CONCEPT PLAN 125 LOTS

2024-96432 Georgetown Prime Ranchettes Water Utility Evaluation

Water Utility Evaluation - Georgetown Prime Ranchettes

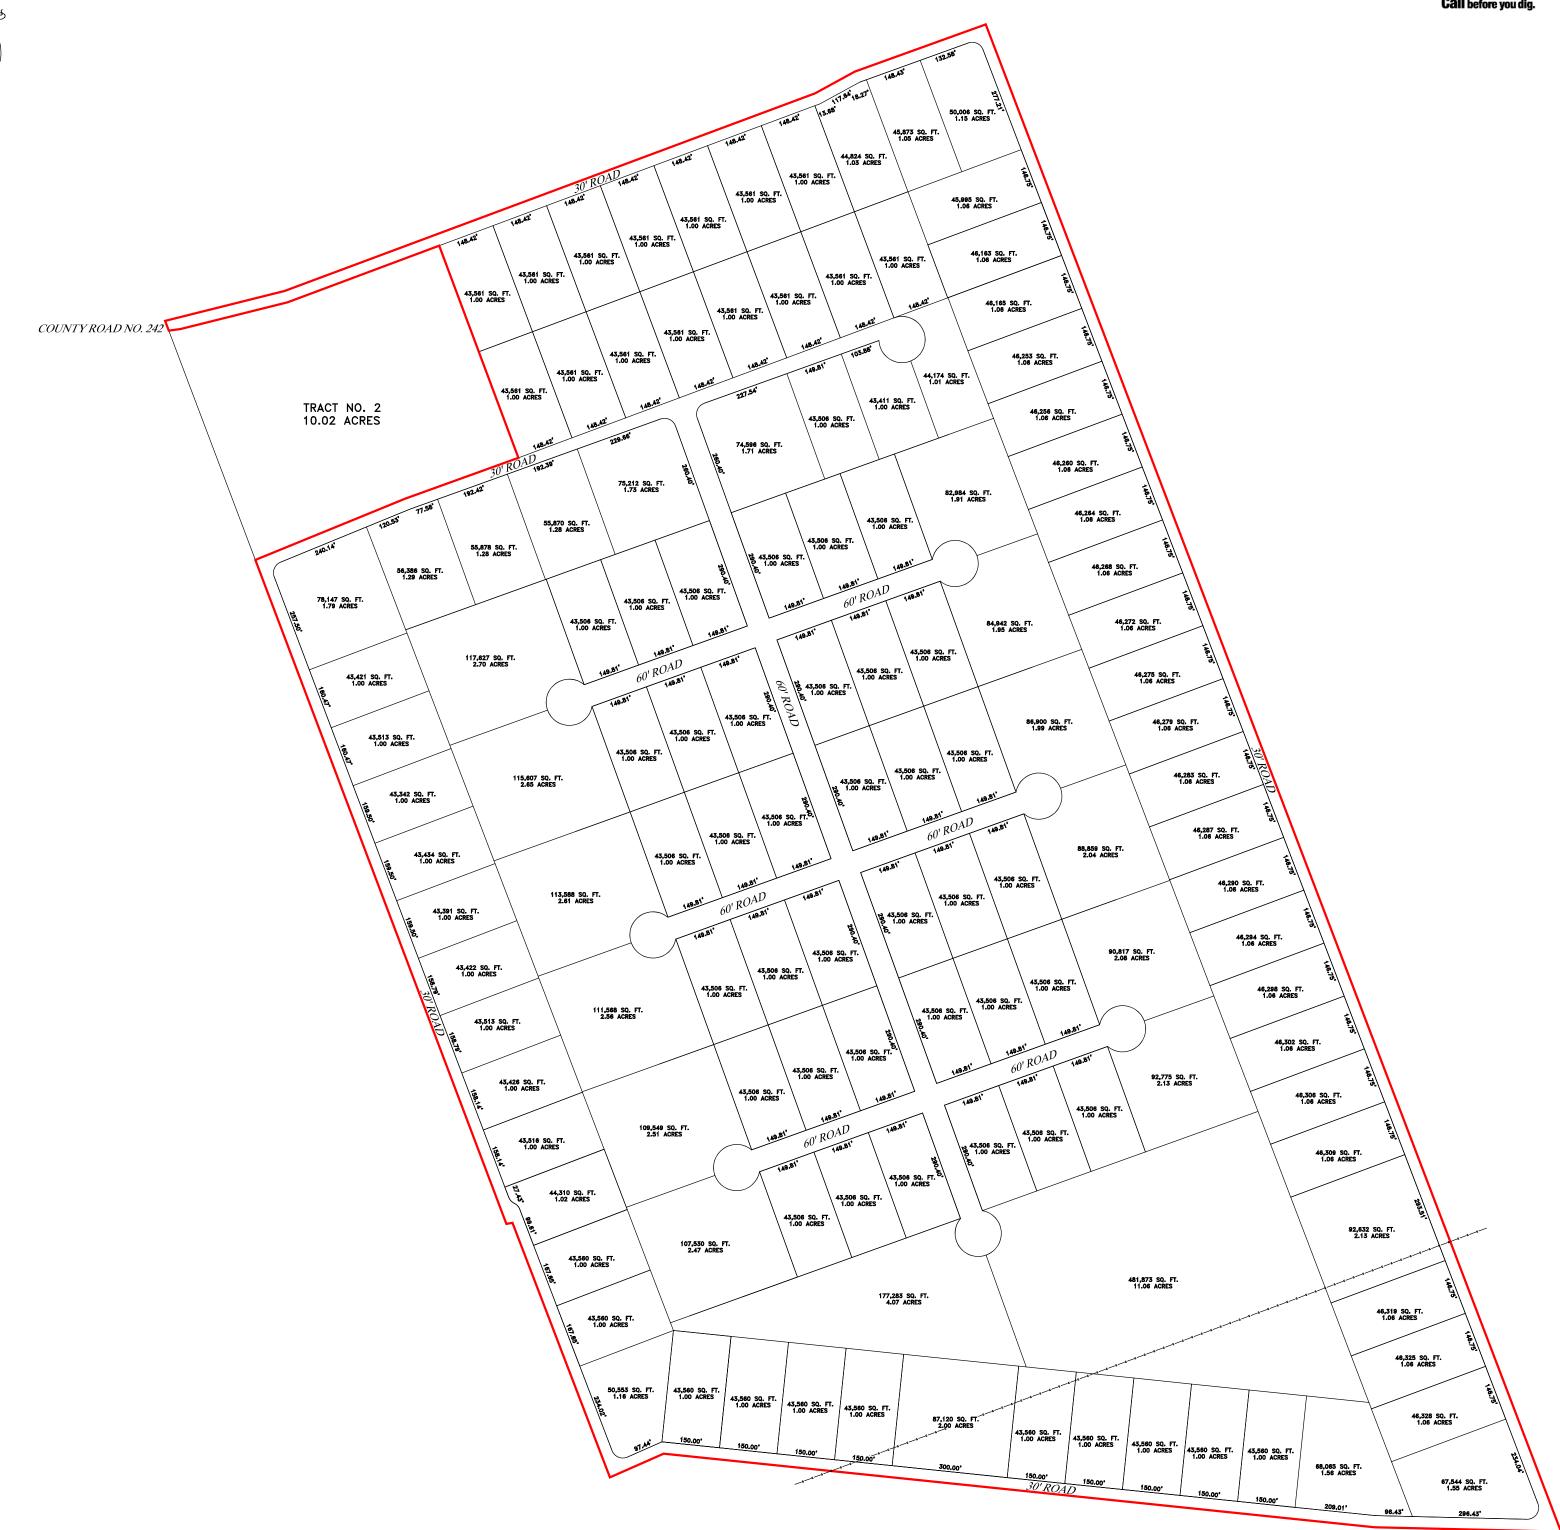
In order to provide domestic and fire flow for this use, at this location: Master plan project C-27T05 on FM 970 will need to be completed before development can commence. The developer can then construct a 12-in feed (approx. 7,650 ft) extended from the new 24-in main on FM 970 to serve the site. It was assumed the site would then be supplied by a new 8-in extended from the new 12-in pipe along CR 252 and CR 251.

Pressures will be high across the site, so an entrance PRV will be required.
